9105 STEELE CREEK RD

CERTIFICATE OF COMPLETION/OPERATION PERMIT

INDIVIDUAL WATER AND WASTEWATER SYSTEMS PROGRAM
APPLICATION FOR SERVICES

MECKLENBURG COUNTY HEALTH DEPARTMENT
SITE EVALUATION REPORT
SERIAL NUMBER 20541

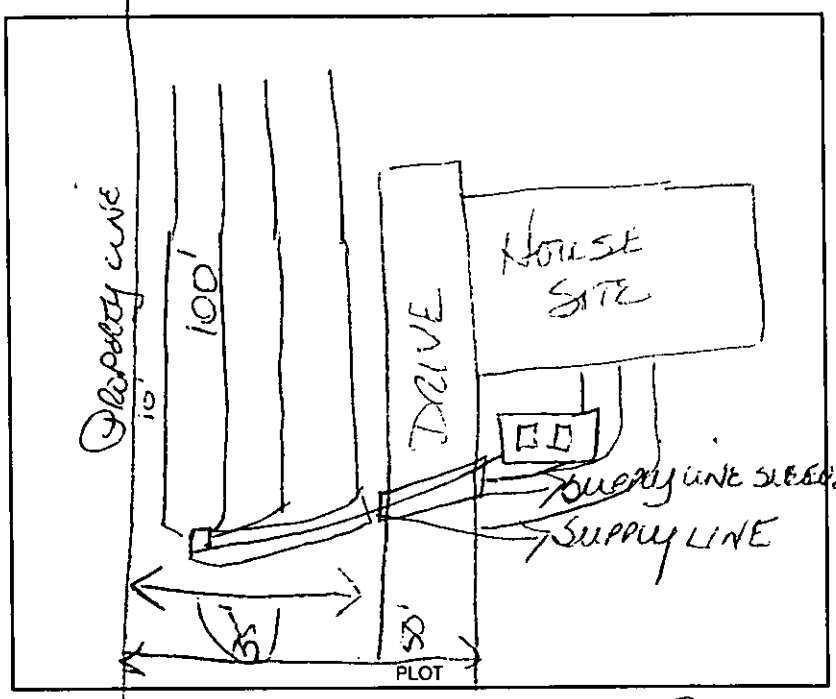
COMMENTS: ① SOILS BROUGHT IN ABOUT 2' AROUND FRONT OF HOUSE.

② SUPPLY LINE TO BE INSTALLED ALONG EXISTING SUPPLY DITCH.

PROPOSED PLOT PLAN

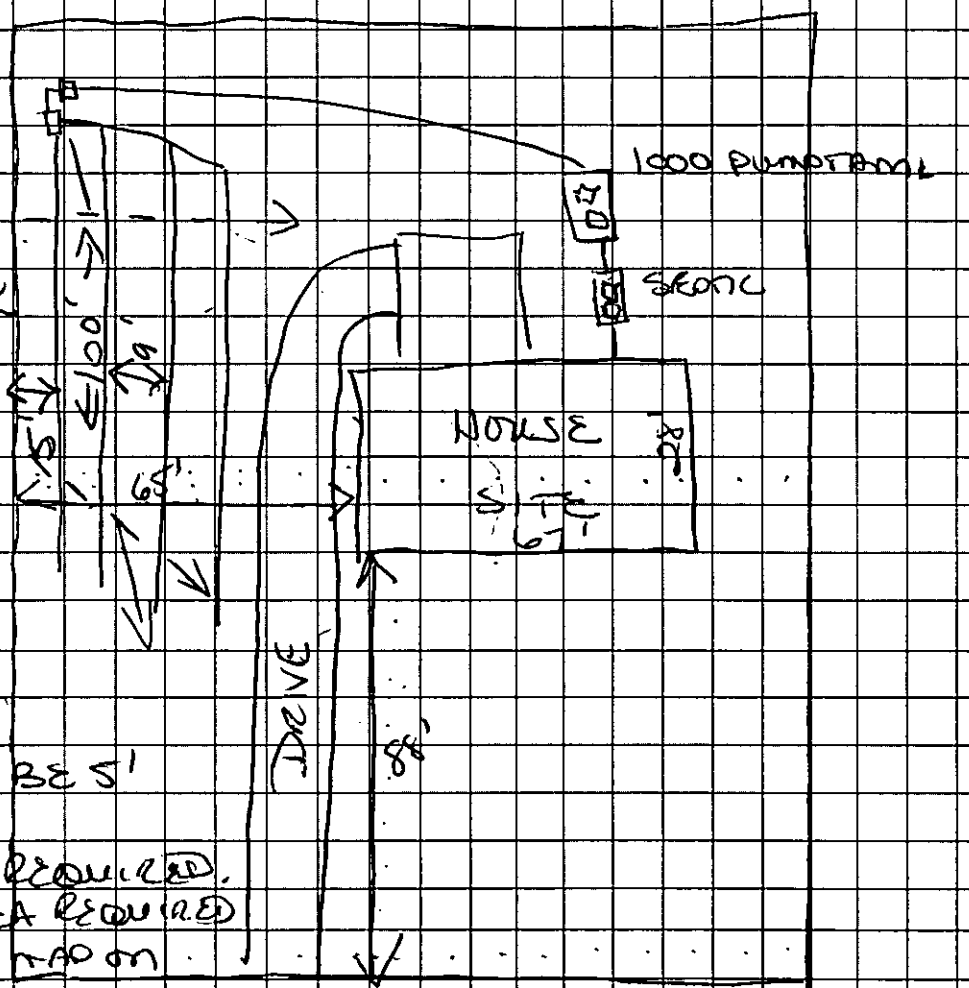
(1) 1500 SEPTIC TANK
(2) 1000 PUMP TANK W/ SEWAGE PUMP
(3) (1) WASHER BOX
(1) DBOX
(4) SYSTEM SHALL BE INSTALLED ON CONTOUR.
(5) 4 TRENCHES @ 3' X 100' X 12"
(6) SYSTEM SHALL BE 5' OFF PROPERTY.
(7) PUMP WILL BE REQUIRED.
(8) NO REPAIR AREA REQUIRED REFER TO PLAT MAP ON FILE.
(9) TRENCH DEPTH = 24"

PROPOSED PLOT PLAN

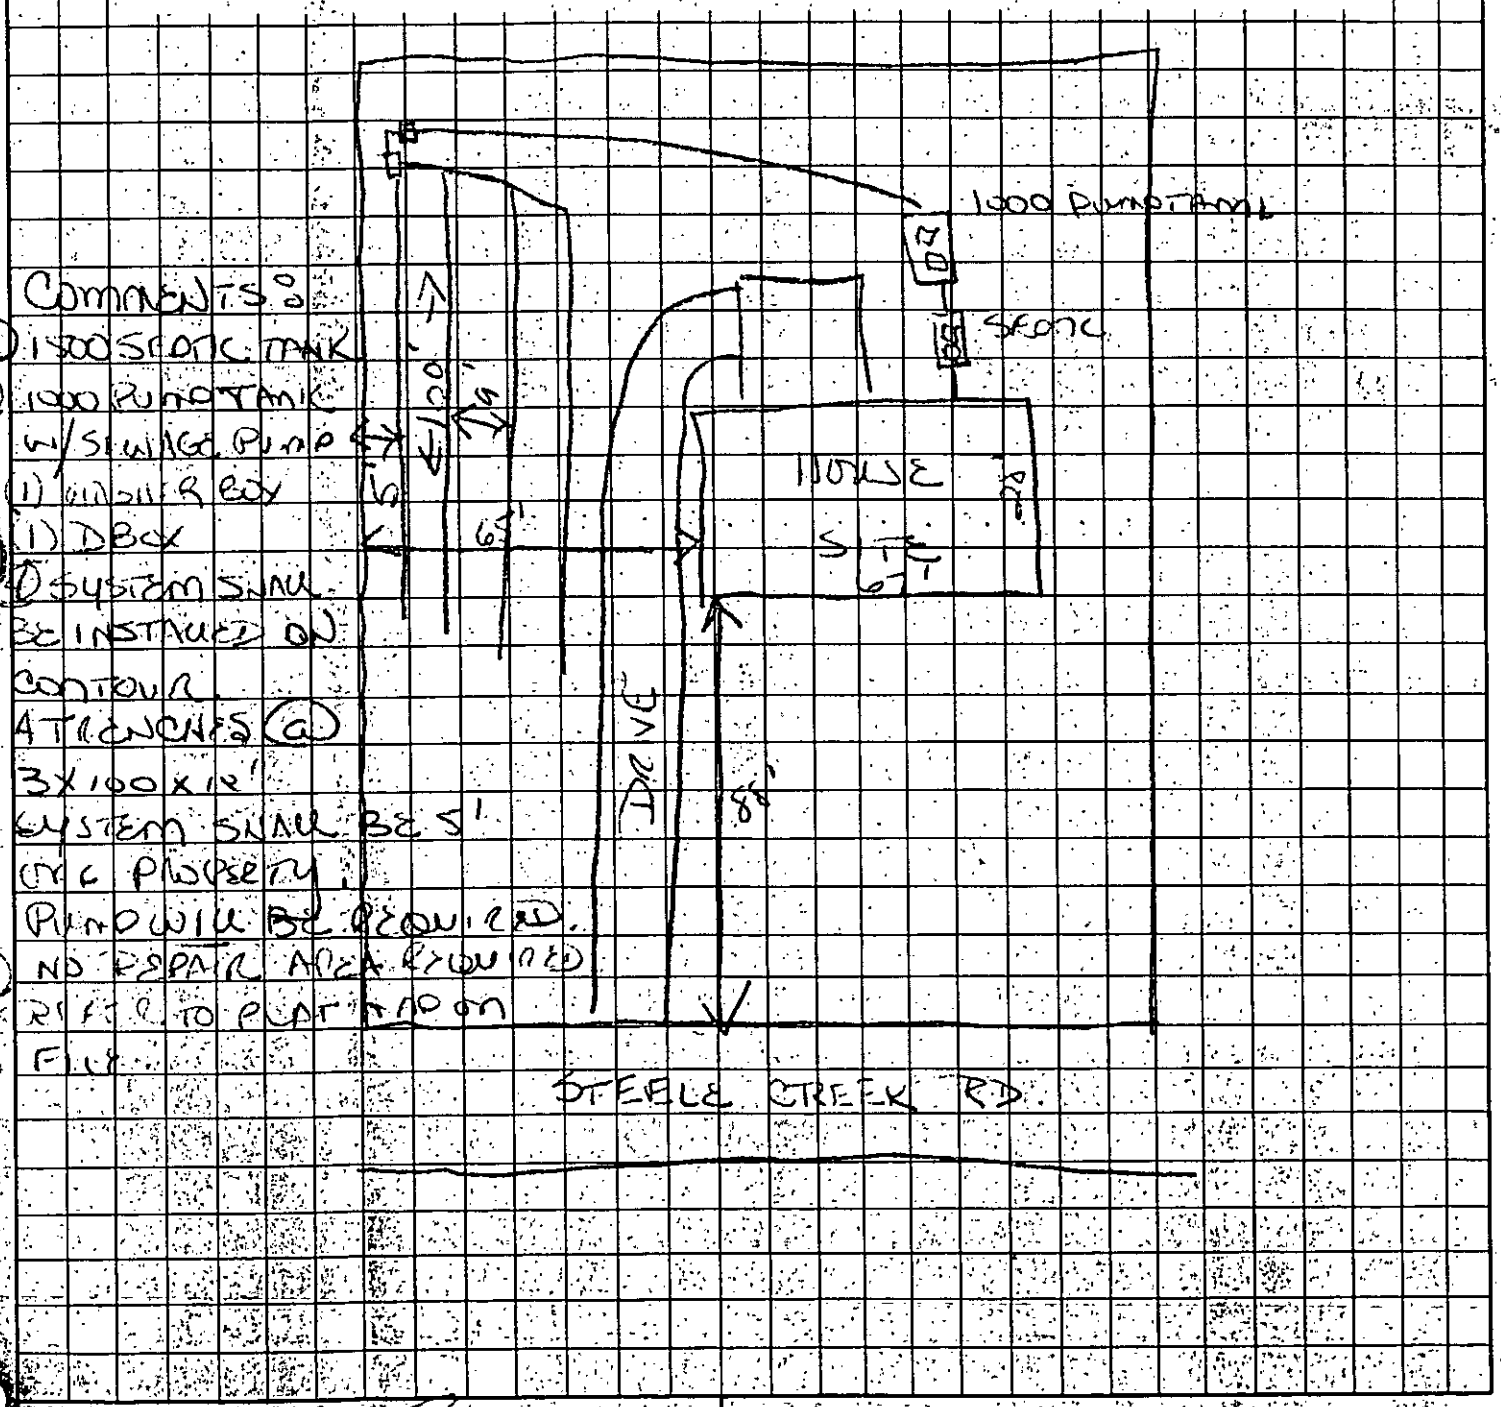
1. 1500 SEPTIC TANK
2. 1000 PUMP TANK W/ SEWAGE PUMP
3. 1) [illegible] BOX
   1) D BOX
4. SYSTEM SHALL BE INSTALLED ON CONTOUR
5. 4 TRENCHES @ 3' X 100' X 12"
6. SYSTEM SHALL BE 5' OFC PROPERTY.
7. PUMP WILL BE REQUIRED.
8. NO REPAIR AREA REQUIRED
   REFER TO PLAT MAP ON FILE
9. STEELE CREEK RD.

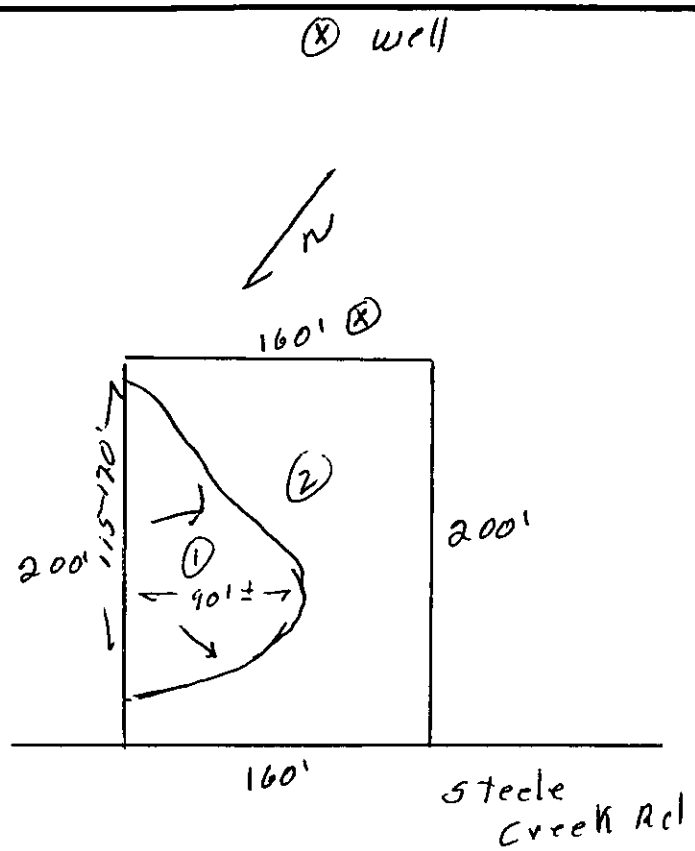
Comments: Not sure if 12" repair is required - .3gal/ft²/day LTAR

CERTIFICATE OF COMPLETION/OPERATION PERMIT

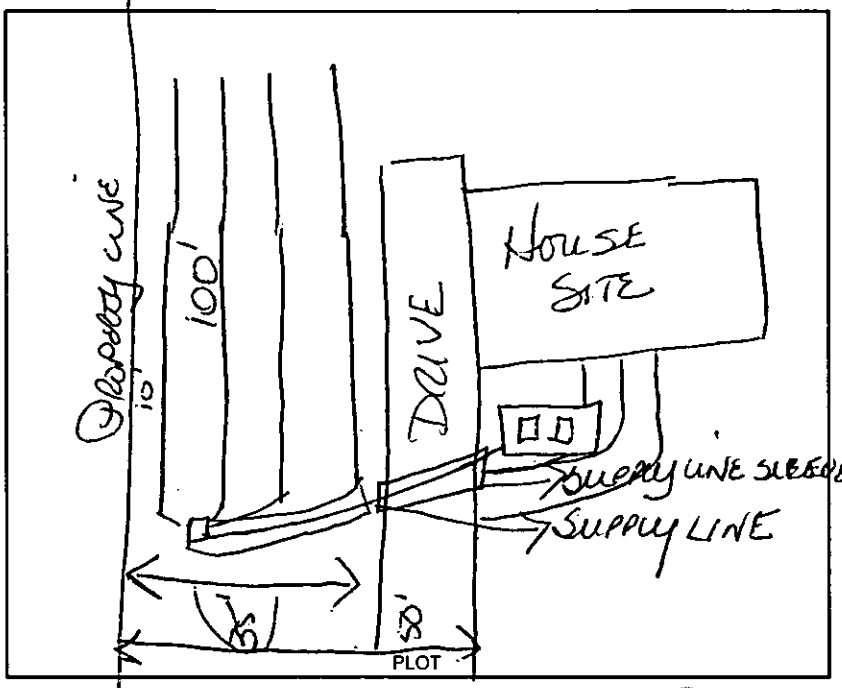
COMMENTS: ① Soils Brought In About 2' Around Front Of House.
② Supply Line To Be Installed Along Existing Supply Ditch.

CERTIFICATE OF COMPLETION/OPERATION PERMIT

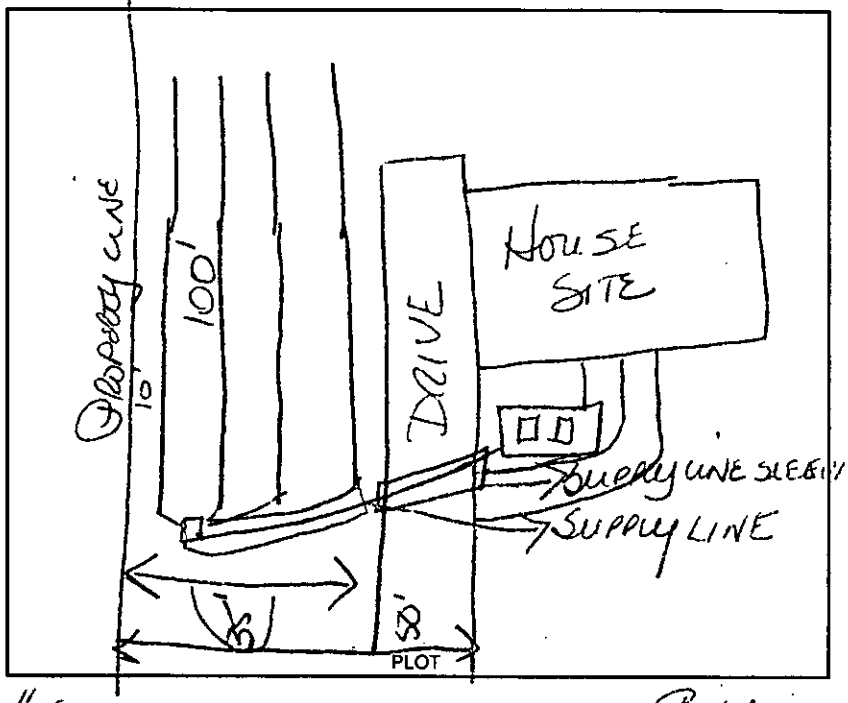
COMMENTS: ① Soils Brought in about 2' around front of House.
② Supply line to be installed along existing supply line.

PLOT OF SYSTEM

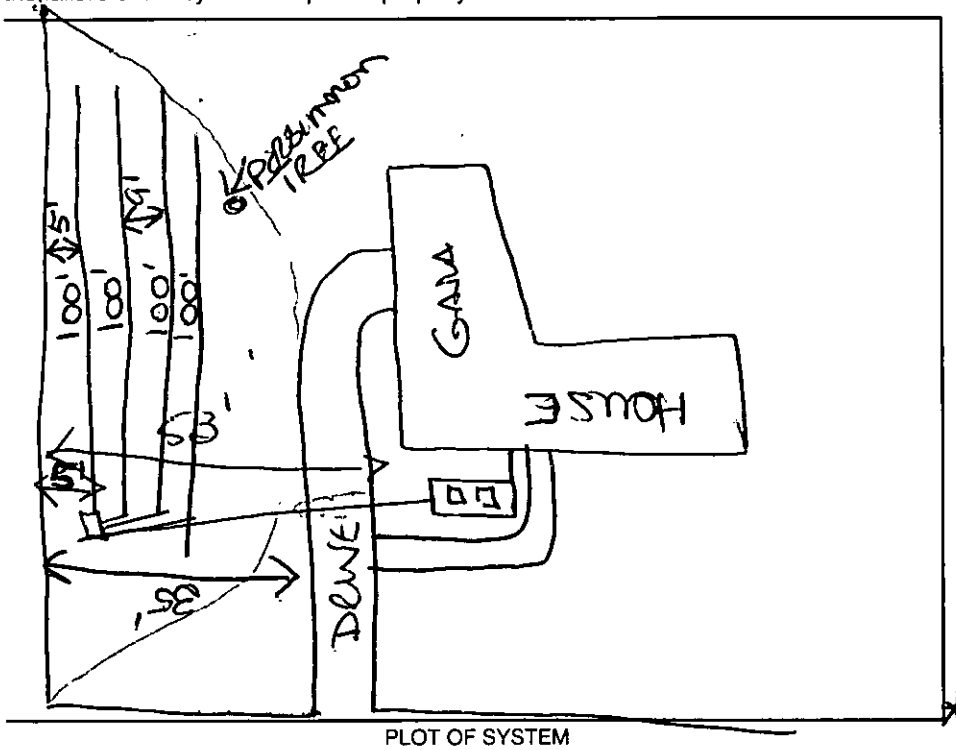
Comments: TANK TO BE LOCATED ABOVE GROUND TO MAINTAIN 24" TRENCH LEVEL - SYSTEM TO BE LOCATED 50' FROM ANY WELL - TREE TO BE REMOVED IN ARES BEING SYSTEM - THERE SHALL BE NO DRIVING OVER DRAINFIELD.
